Access Compliance Report

Public Rights-of-Way

Intersection ID: N/A	Main Street: YORK_CENTER	Cross Street: N/A	Location: NE
ADA ID: FF38DA379606	Ramp Type: PerpDiag	Initial Pass/Fail: Fail	Overall Compliance: No
Severity Score: 33.75			
Codes/Mitigation Info/Possible Solution		Field Measurements/Component Compliance

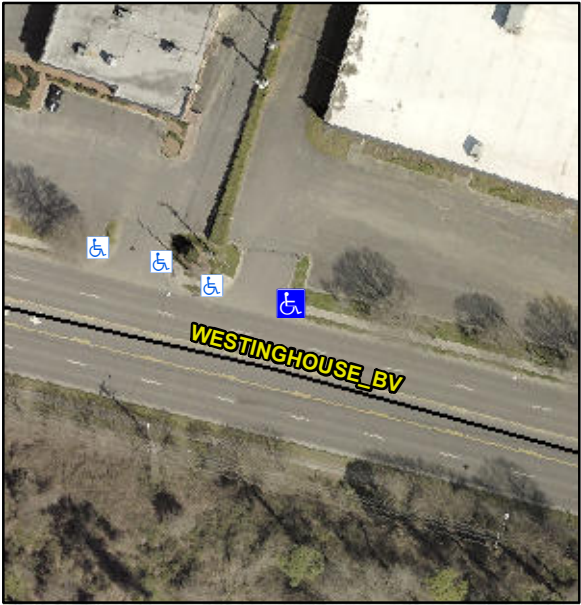
Possible Solutions:	Compliance	Description	Data	Compliance	Description	Data
	Remove & Replace Curb Ramp With Two New Directional Ramps or Equivalent.	N/A	Ramp Length (in)	82.0	Yes	Ramp Slope (%)	7.8
		No	Ramp Width (in)	41.0	No	Ramp XSlope (%)	10.1
		N/A	Flare Type LT	N/A	N/A	Flare Type RT	N/A
		N/A	Flare Slope LT (%)	N/A	N/A	Flare Slope RT (%)	N/A
		N/A	Flare Traversable LT?	N/A	N/A	Flare Traversable RT?	N/A
		N/A	Landing Length (in)	N/A	N/A	DWS Provided?	N/A
		N/A	Landing Width (in)	N/A	N/A	DWS Contrast?	N/A
		N/A	Landing Slope (%)	N/A	N/A	DWS Length (in)	N/A
		N/A	Landing X Slope (%)	N/A	N/A	DWS Full Width?	N/A
		N/A	Landing Curb? (Y/N)	N/A	N/A	DWS Offset (in)	N/A
		N/A	Shared Landing?	N/A			
		N/A	Gutter Ponding?	N/A	N/A	Gutter Slope (%)	N/A
		N/A	Gutter Lip Ht (in)	N/A	N/A	Gutter X Slope (%)	N/A
		N/A	Painted X Walk1?	No	N/A	Painted X Walk2?	No
			X Walk 1 Direction	To NW		X Walk 2 Direction	To S
		N/A	X Walk 1 Width (in)	N/A	N/A	X Walk 2 Width (in)	N/A

X Walk 1 Slope (%)	1.2		X Walk 2 Slope (%)	3.7
			X Walk 1 X Slope (%)	5.3		X Walk 2 X Slope (%)	0.7
		N/A	Ramp inside XWalk1?	N/A	N/A	Ramp inside XWalk2?	N/A
<p>Surveyor Notes:</p> <p>N/A</p> <p>PROW/ADA:</p> <p>Not Found, R304.5.1, R304.5.3</p>			Road Slope (%)	6.0	N/A	Clear Space?	N/A
			Road X Slope (%)	3.7	N/A	Clear Space to XWalk (in)	N/A
<p>Total Cost:</p> <p>\$ 3200.00</p>		N/A	Any Obstructions?	N/A	N/A	Storm Grate/Utility Hazard?	N/A
			Obstruction Type			Storm Grate/Utility Type	
				N/A			N/A
				Yes		Surface Condition? (G/P)	Good
